Your Comment on The Point Mission Bay

Watercare has reviewed the lodged consultation application insofar as it relates to the provision of water supply and wastewater services to support the proposed development. The application seeks approval for the construction of approximately 260 new Independent Living Units (ILUs) distributed across five proposed buildings within The Point / East Cliffe Retirement Village.

Figure 2.

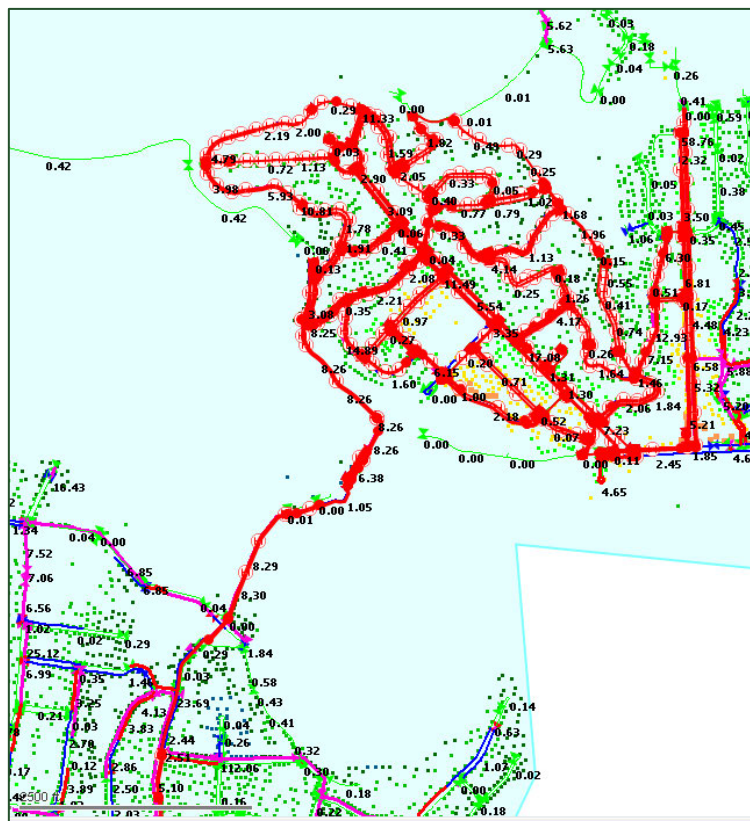
2. Consequently, the scope of the required network upgrades has expanded beyond those previously identified. **Figure 2.** below illustrates the upstream network configuration servicing the development site and highlights the interconnections between the existing water mains (WMs).

Figure 3.

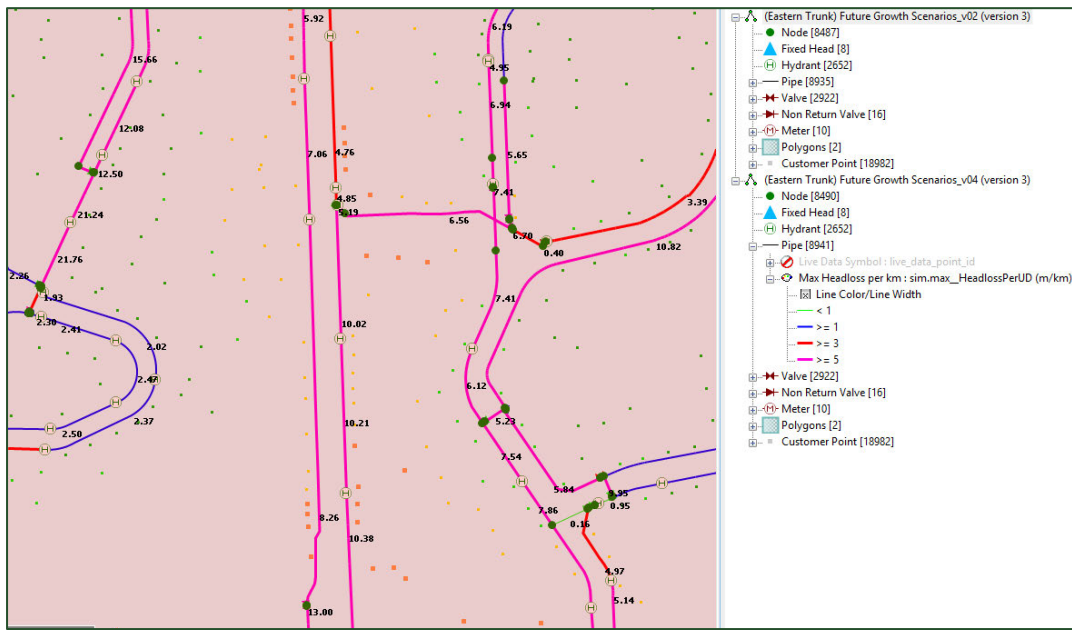
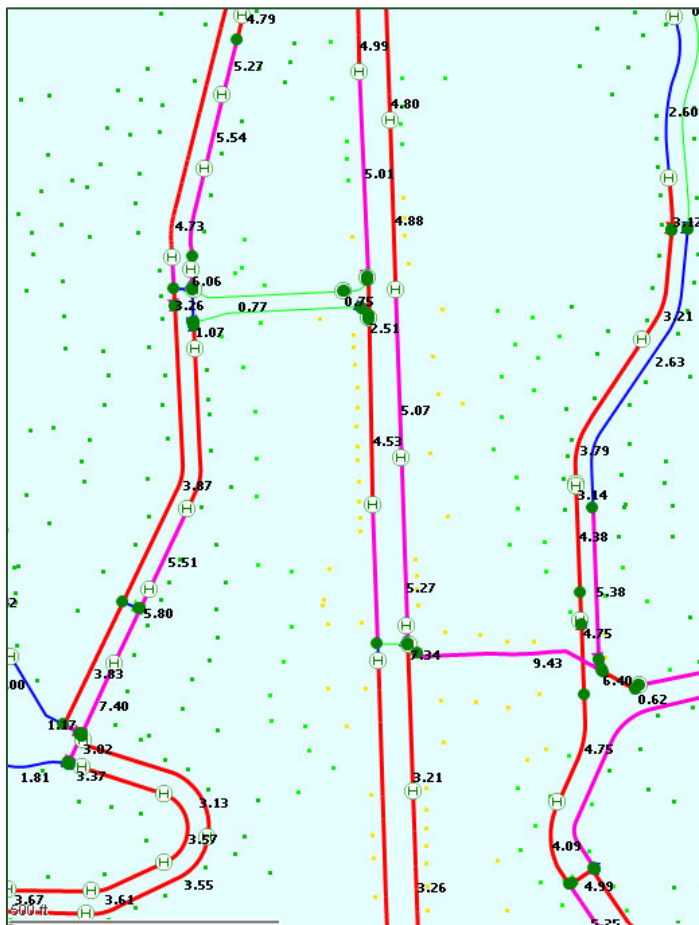
System performance figures have been provided to demonstrate the differences between the existing scenario and the 20-year future scenario, including the associated demand assumptions. With the proposed reticulation upgrades implemented, the resulting **maximum unit head loss values** are presented in **Figures 3 and 4**, illustrating network performance **before and after the upgrades**, respectively, for reference.

Figure 5.

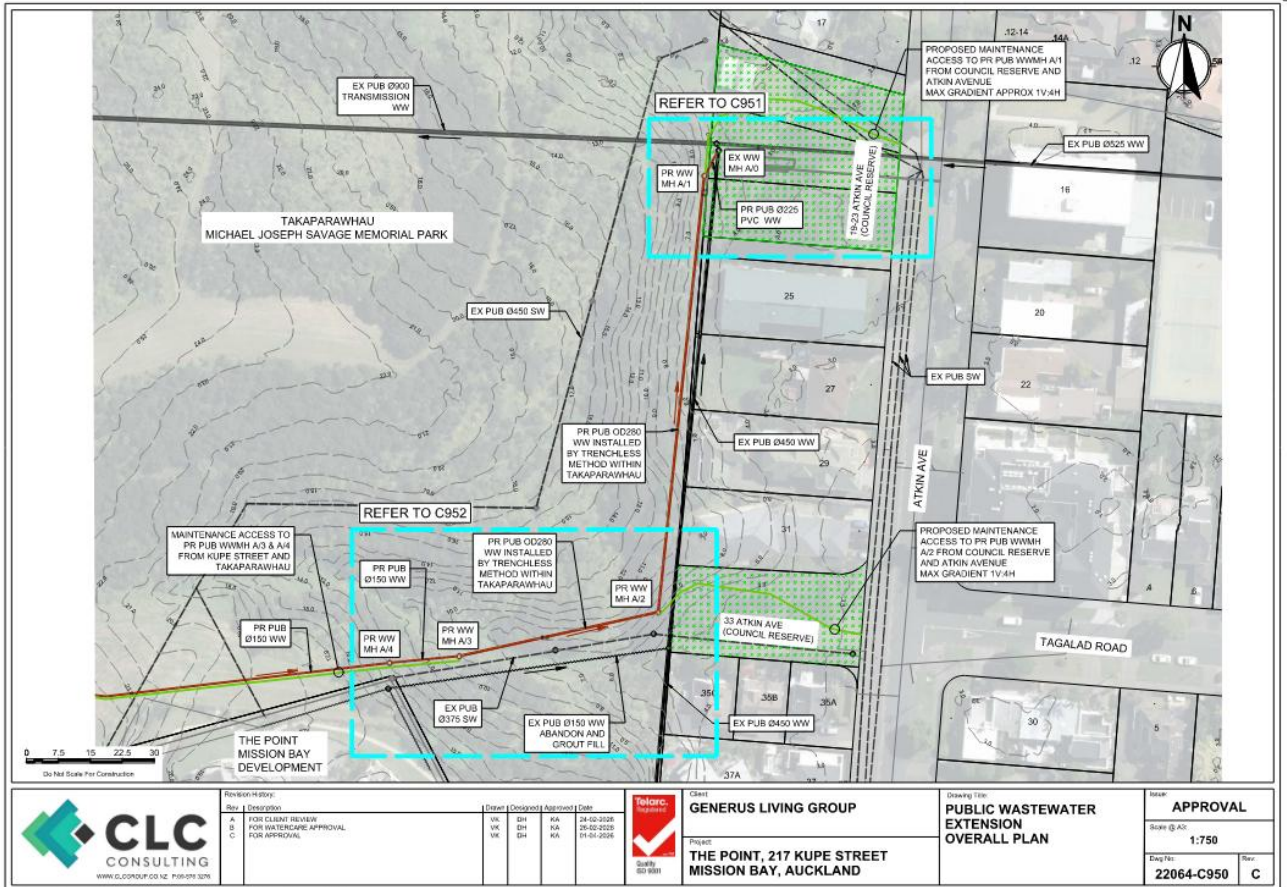
The submitted preliminary design for the proposed wastewater network extension has been reviewed in collaboration with Watercare as per below **Figure 5**. Following this initial assessment, preliminary comments and observations have been identified.

1. The proposed wastewater pipeline in this location will require further refinement. Given that this section traverses steep terrain and crosses a significant overland flow path, any modification to the design is likely to have implications for the final alignment as well as long-term maintenance access. This may include, but is not limited to, the need for deeper manholes, drop structures, or other specialised infrastructure to accommodate the challenging topography and hydraulic conditions.

Updated detailed design drawings reflecting these adjustments will be required, after which the plans can be reviewed further to assess constructability, operational impacts, and compliance with relevant standards.

2. Provision shall be made to ensure ongoing accessibility for future Watercare operations and maintenance activities. The design must allow safe and unobstructed access to all assets for inspection, routine servicing, and emergency interventions throughout the asset lifecycle.

6. Existing services clearance to be maintained at all times. The works shall ensure that required horizontal and vertical separation distances from existing utilities are achieved in accordance with relevant standards and Watercare requirements. Where conflicts cannot

be avoided, appropriate protection, relocation, or redesign solutions must be developed in consultation with the relevant asset owners.
